Philips Image Guided Therapy Corporation
URGENT Field Safety Notice
Philips Laser System (LAS-100) Error 500

JUN-2022

Reference: LAS-100 Error 500, 2022-IGT-IGTD-002

Figure 1: Example of an Error 500 visual alert

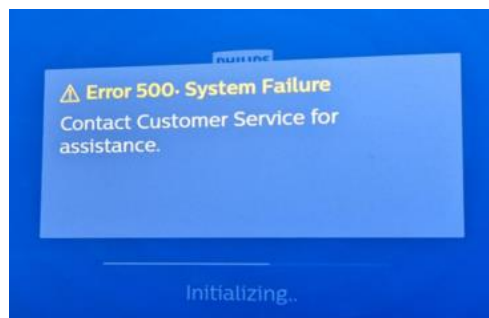
Philips has identified an intermittent mechanical fault with the LAS-100 Philips Laser Systems manufactured prior to 18-MAY-2022. For affected units, on occasion, the system may detect an inoperable hardware component during power up. When this issue occurs, the user will be visually alerted on the system display as “Error 500 – System Failure” (see Figure 1). The user will not be able to proceed until the error is cleared. In this event, a delay in treatment may occur since the device is not able to fully initialize to a ready state. This fault was identified after seven (7) complaints of Error 500 were received. To date, Philips has not received reports of patient or user harm due to this issue.

Philips internal testing confirms that 1-3 reboots of the system will temporarily resolve the issue. Philips also recommends the continued use of the Philips Laser System, and to follow the Operator's Manual, as there is no expected harm to the user or patient.

Philips will notify all affected customers and arrange for a Field Service Engineer (FSE) to replace the shutter assembly with an improved shutter assembly free of charge beginning June 2022,. The updated assembly improves the Philips Laser System’s performance and integrity.
